HISTORIC AND DESIGN REVIEW COMMISSION

HDRC CASE NO: 2021-357
ADDRESS: 611 MUNCEY
LEGAL DESCRIPTION: NCB 1301 (BURLESON SUBD), BLOCK 2 LOT 24
ZONING: RM-5, H
CITY COUNCIL DIST.: 2
DISTRICT: Dignowity Hill Historic District
APPLICANT: Felix Ziga/Ziga Architecture Studio PLLC
OWNER: Bob Prado/DELAFIELD INVESTMENTS LLC
TYPE OF WORK: Construction of a 1.5-story, single-family residential structure
APPLICATION RECEIVED: July 16, 2021
60-DAY REVIEW: Not applicable due to City Council Emergency Orders
CASE MANAGER: Edward Hall

The applicant is requesting a Certificate of Appropriateness for approval to construct a 1.5-story, single-family residential structure on the vacant lot at 611 Muncey, located within the Dignowity Hill Historic District.

PROPOSED EXTERIOR
ELEVATIONS

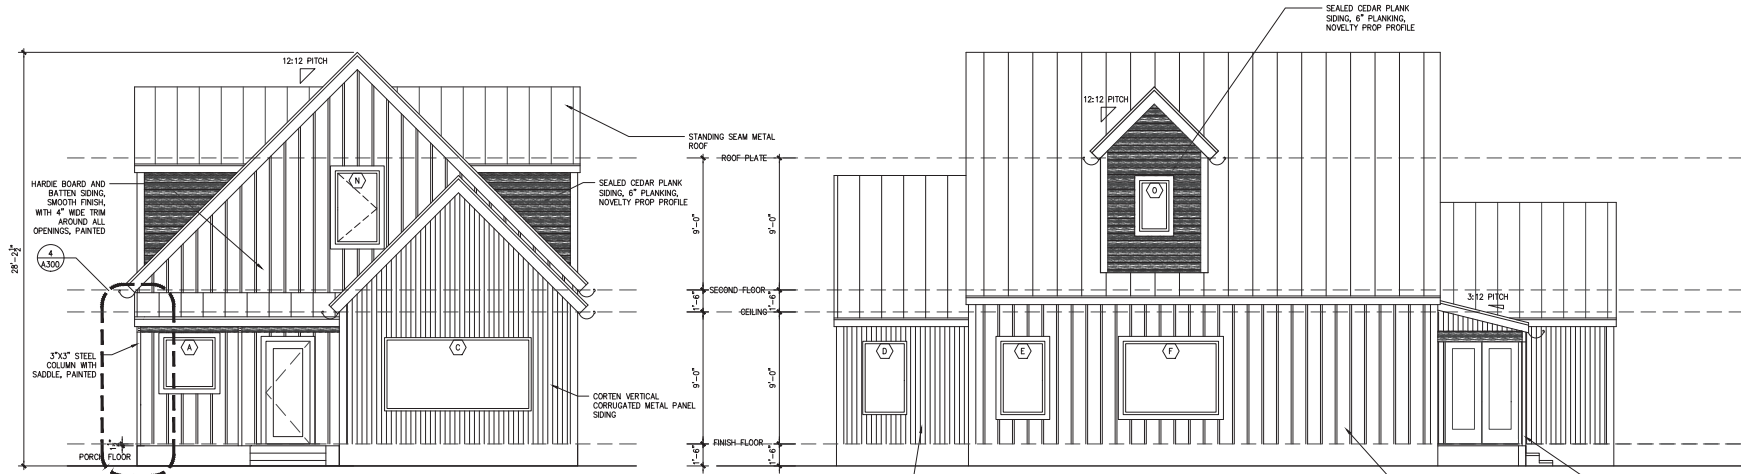
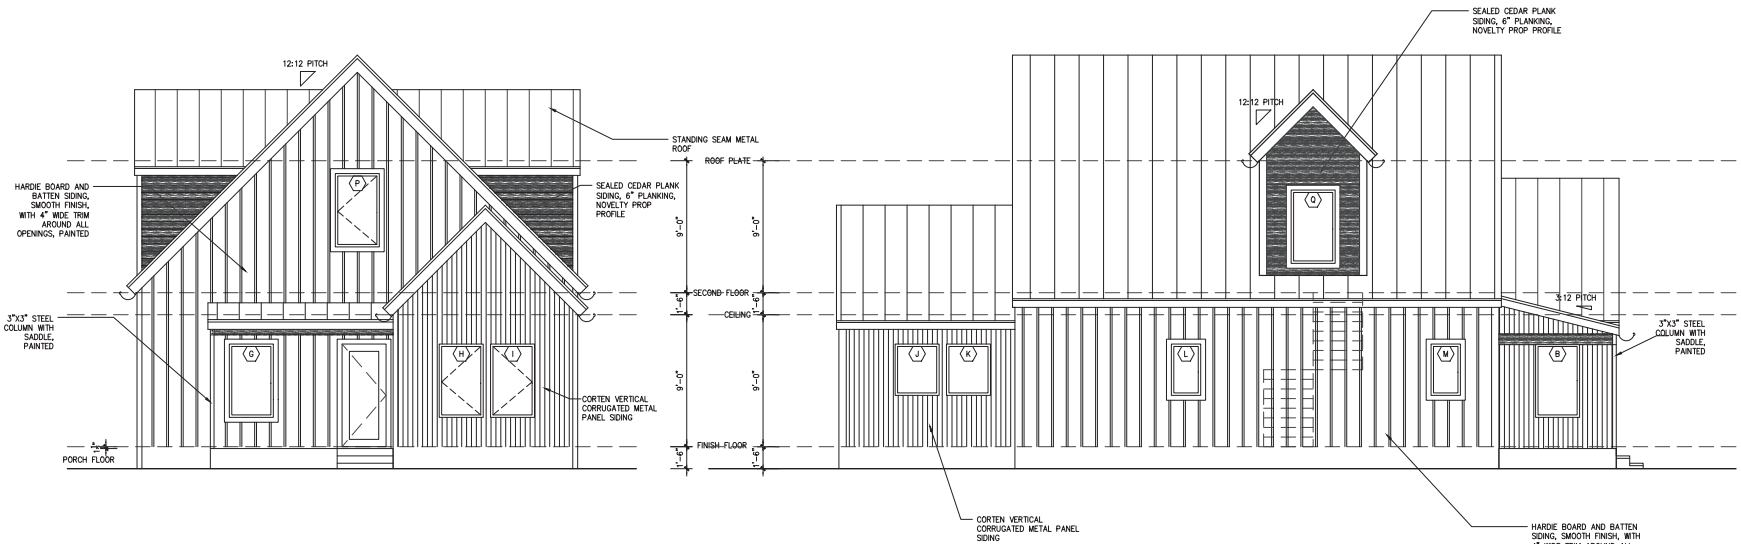
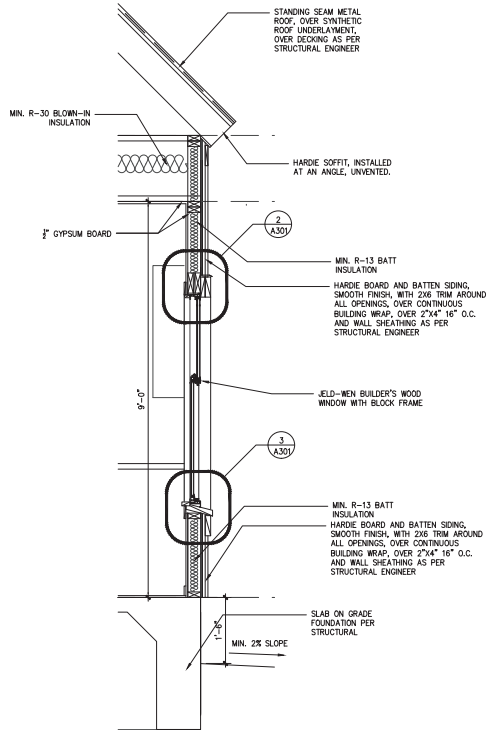
- i. **MATERIALS** – The applicant has proposed materials that include composite board and batten siding, sealed cedar plank siding, corten corrugated metal siding, steel columns, a standing seam metal roof, and wood windows. Staff finds the installation of composite board and batten siding and a standing seam metal roof to be appropriate and consistent with the Guidelines as well as historic examples found within the district. Staff finds that board and batten siding should feature a smooth finish, boards that are twelve (12) inches wide and battens that are 1 – ½" in width. Additionally, staff finds that the proposed standing seam metal roof should feature smooth panels that are 18 to 21 inches in width, seams that are 1 to 2 inches in height, a standard galvalume finish and a crimped ridge seam. A low profile ridge cap can be submitted for review and approval by the Commission for new construction. Staff does not find the use of corten corrugated siding, cedar plank siding and steel columns to be consistent with the Guidelines, as these materials as not found historically within the district in single-family residential construction.

- k. FENESTRATION PROFILE – The applicant has proposed fenestration profiles that feature large, picture windows as well as fixed windows. While the applicant has proposed individually scaled window openings to be sized consistently with those found historically within the district, the proposed windows do not feature operable sashes, as recommended in staff’s standards for windows in new construction. Additionally, the applicant has proposed large, picture windows that feature the size of two or three individually sized traditional windows without separating mullions and operable sashes. Staff finds that the applicant should proposed fenestration profiles that feature individual windows with operable sashes. On the front and side elevations, larger window openings should be separated by mullions and feature individual window openings with windows that feature operable top and bottom sashes in a one over one profile.

- l. ARCHITECTURAL DETAILS – Generally, staff finds the proposed architectural details to be appropriate as they relate to massing and roof forms. Staff finds that materials and fenestration profiles should be amended as noted in findings i and k, to be consistent with the Guidelines and staff’s standards.

- iii. That the proposed corrugated steel siding, steel columns and cedar siding be eliminated and that materials that are consistent with the Guidelines and those found historically within the district be used.

- iv. That the proposed wood windows adhere to staff’s standard specifications, as noted in finding j and in the applicable citations.
- v. That fenestration profiles be modified as noted in findings k and l. Windows should feature individual heights and widths that are comparable to those found historically within the district. Windows should feature operable sashes in a one over one profile.
